ASSOCIATION OF
AMERICAN RAILROADS

AAR Interchange Rules Revisions

Presented to NARMO 2014 by

2014

RULE 5 – AIR BRAKE HOSES, HOSE SUPPORTS, AND TRAIN LINES

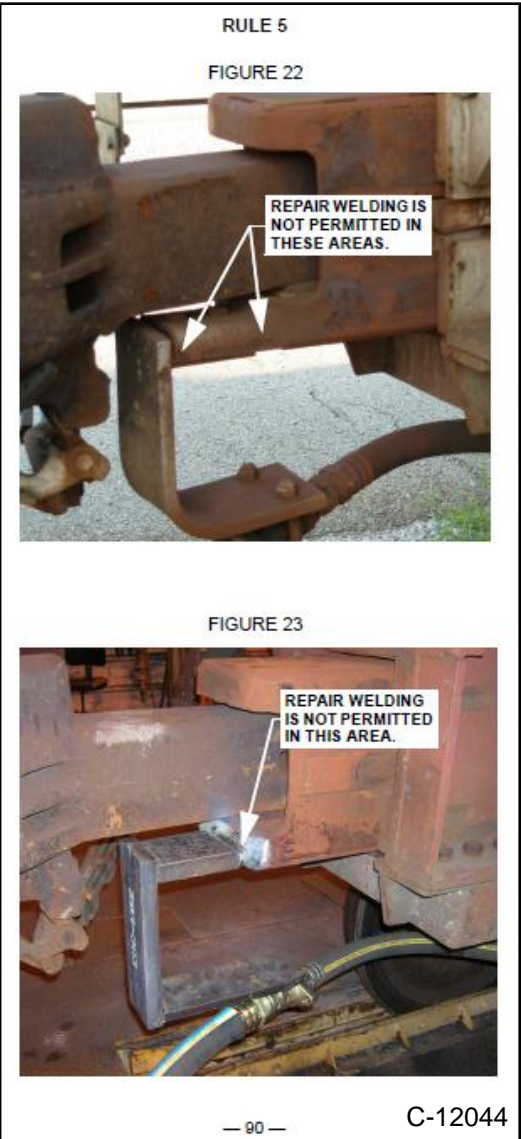
Added Figures 16 and 17
from rule 4 and re-numbered

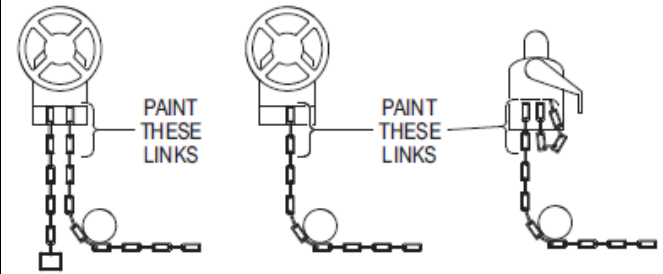
11. The hand brake load bearing chain in all hand brakes must be painted as an indication the hand brake is not applied.

- With the hand brake fully released, paint the first three (3) visible links as indicated below, when on shop or repair track.
- The color shall be Fluorescent Orange or White.
- When inspecting cars, if painted chain links on the load bearing chain are not visible then it must be determined if the hand brake is released.
- Painted links being hidden from view is not an indication of a fully applied hand brake.

FIGURE G

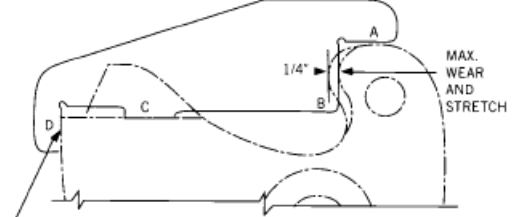
Editorially revised the Figure Cited in 2.a.

a. 7/8-inch F-type retainer bolt must be replaced with pin assembly that meets the requirements of AAR Specification M-119 when a two-flange trainline bracket is suspended from the pin. See **Figure I** for example application. (A bolt must be used if the trainline bracket has only one flange.)

POINT 'D' MUST NOT TOUCH OR CLEAR MORE THAN 1/4" WITH A, B, & C SEATED.
